APPLICATION NO PA/2015/0161

DEVELOPMENT Listed building consent to erect a two-storey extension (resubmission of PA/2014/0880)

LOCATION Cleatham House Farm, unnamed road through Cleatham from B1400 to B1398, Manton

SUMMARY RECOMMENDATION Refuse consent

PA/2015/0160 & PA/2015/0161 Proposed Elevations
Not to scale

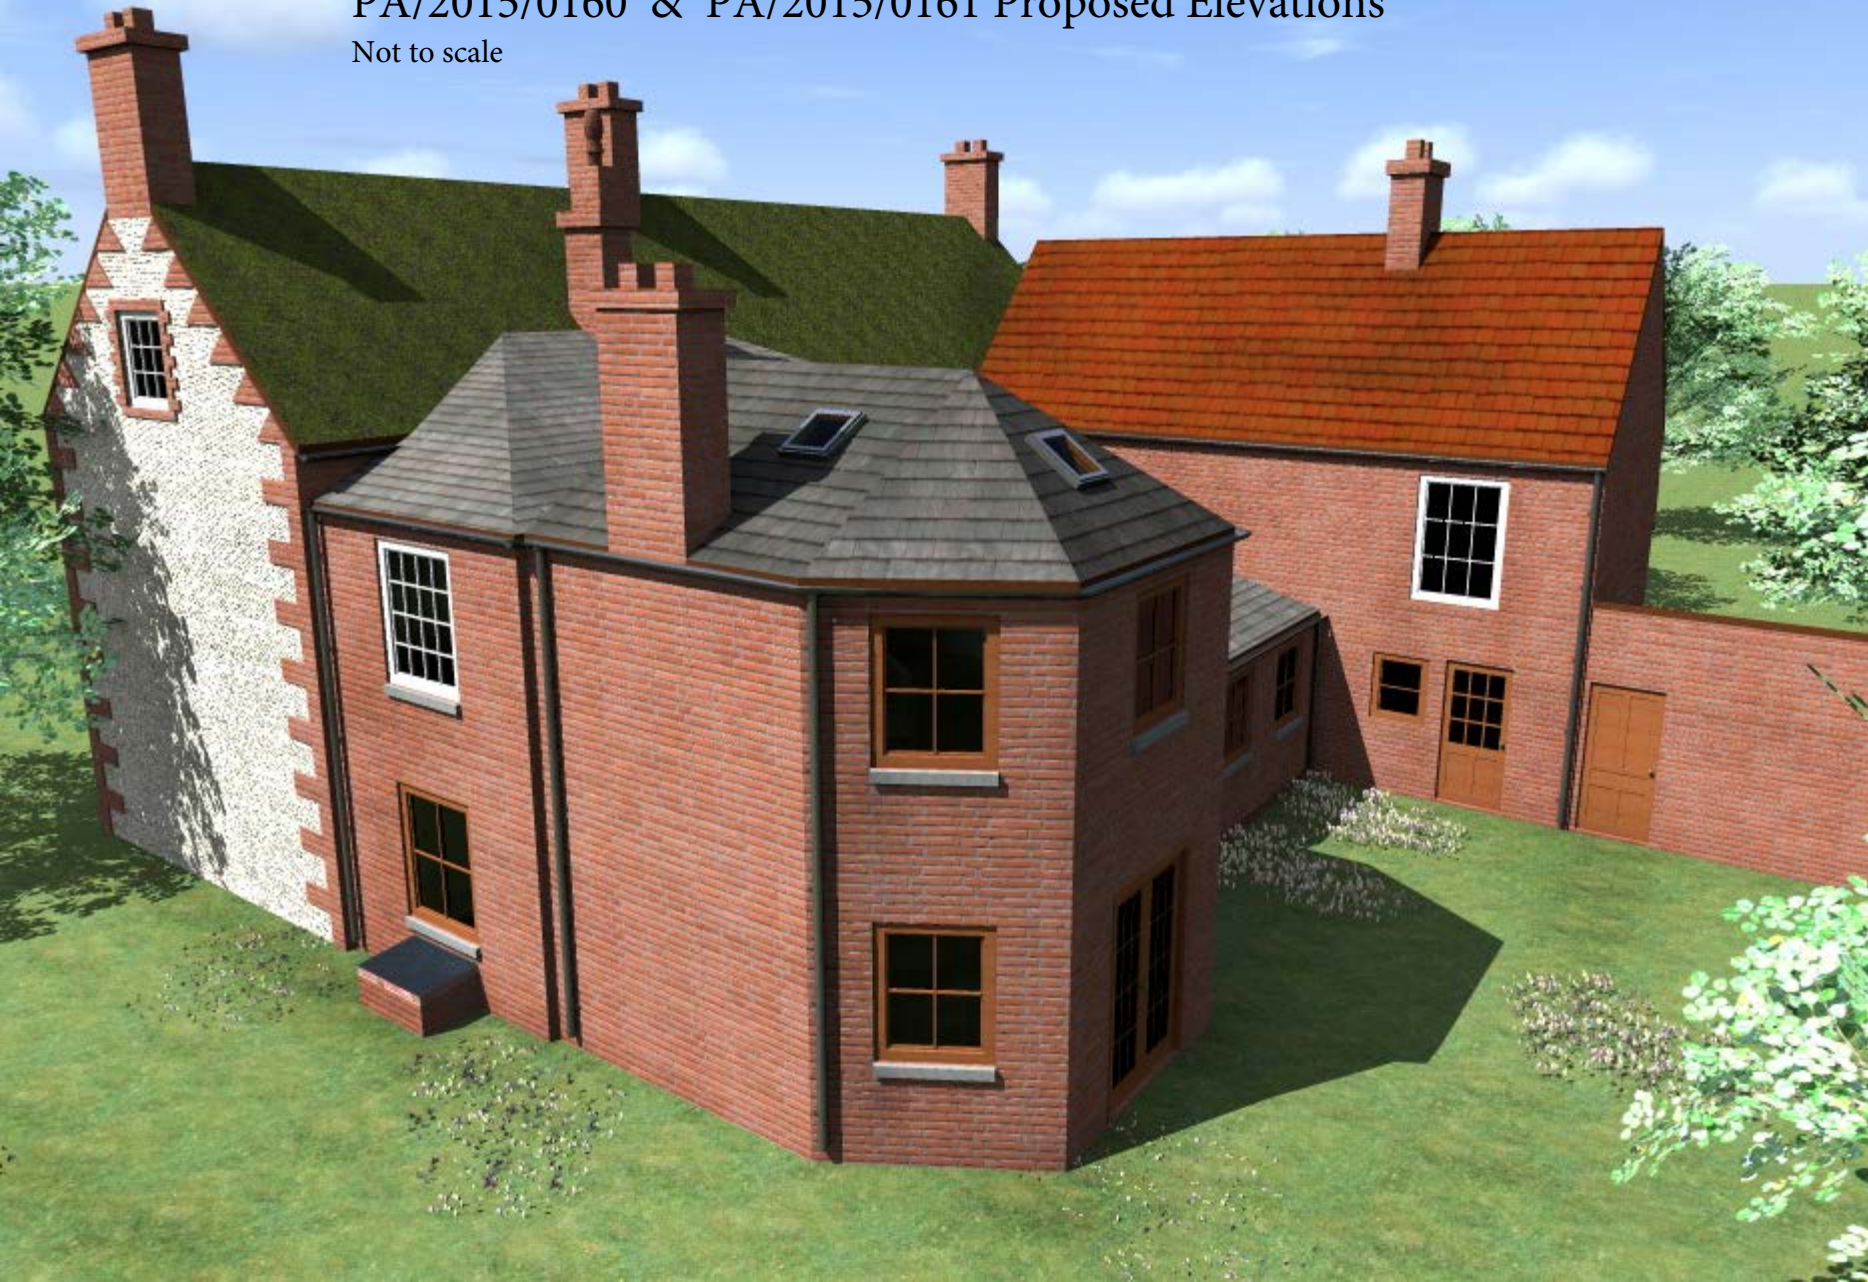
Where this application fails is the relationship between the existing building and the proposed extension. To the south-eastern corner of Cleatham House Farm is another Victorian extension which projects out by almost 3.5 metres. This existing extension has a hipped roof which faces towards the proposed gable; this hip runs into the proposed gable. Due to this arrangement it is clear that the proposed extension is a later addition which does not integrate into the existing building, instead it stands alone as an unplanned addition. Given the awkward arrangement between the proposed extension and the existing building it will appear as an incongruous addition, which detracts from the character and

appearance of the building. This impact is accentuated by the prominence of the gable in the context of the property's attractive side and front elevations at the entrance.

Concerns are also raised regarding the east-facing elevation of the proposed extension, which is a half hexagon with a hipped roof. It should be noted that this arrangement was approved at ground-floor level by an earlier application; however, its prominence is increased by the first-floor addition. This design feature is uncharacteristic of the listed building and the Cleatham House Farm complex; it introduces a new design element and unbalances the extension which has a gable on its opposite elevation. This design is considered to further highlight the proposed extension as an uncharacteristic addition to the existing building. It should be noted that this element will be highly prominent from the footpath to the rear of the property.

The proposed development is found to form a discordant feature and be visually incongruous and as such is contrary to local plan policies DS5 and SPG1, policy CS5 of the Core Strategy and section 7 of the National Planning Policy Framework.

The proposed development is found to cause significant harm to the visual aesthetic of the grade II listed building and not enhance the building's fabric or character and as such is contrary to local plan policy HE5, policy CS6 of the Core Strategy and section 12 of the National Planning Policy Framework.
